| RE: Emission Modification Notification – [[2020050023]] MY 09 R320 BlueTec 4MATIC Update – Emission Modification Category (EMC) #5 | DATE: January 13, 2022 |

Campaign No. 2020050023, January 2022

SUBJECT: **Model R-Class diesel vehicles (V251 platform)**
Model Year 2009
Modification to the emission control system

Figure 6

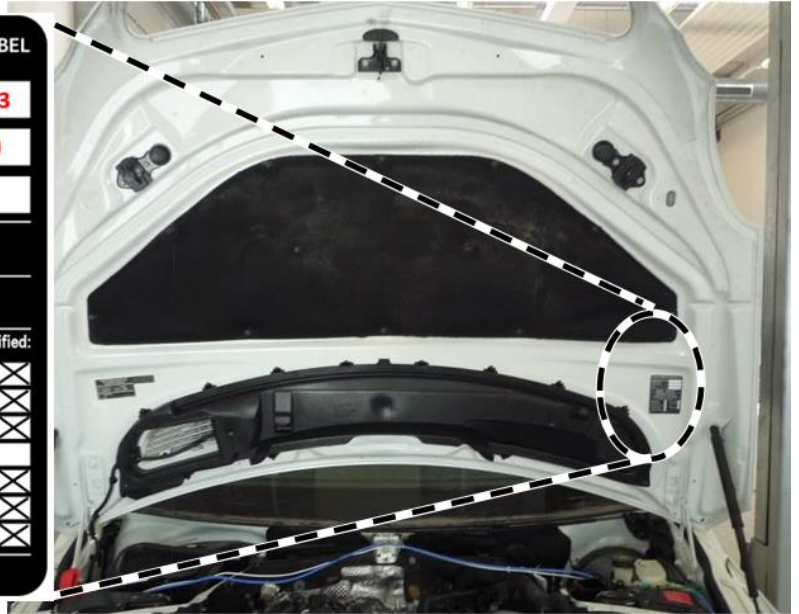
13. Clean the bonding surface of the hood and attach the adhesive label (A 000 584 63 15) (**Figure 6**).

i The fields on the adhesive label must be filled out correctly. Please use black permanent marker. Refer to (**Figure 6**) within the XENTRY procedure.
